Office Action Summary

10/547,337

GELUS ET AL.

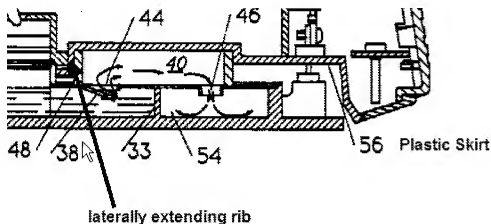
With respect to the limitations of claims 5, 8, 11 and 14, Cuzel et al. disclose the skirt of the iron forming walls (annular conformations 23, 33) of the steam chamber (reservoir/chamber 29; column 5, lines 14-18; column 7, lines 17-23; see Figures 4, 7, 8) and the chamber (29) holding water or steam (column 7, lines 65-67).

Cuzel et al. also discloses the use of elastomer seals between the upper and lower half shells (12, 11; EPDM; column 2, lines 49-50; column 5, line 66 – column 6, line 4) being used due to its characteristics of being able to withstand temperatures of the order of 100°C to 150°C while retaining elastic characteristics and a substantial compressibility.
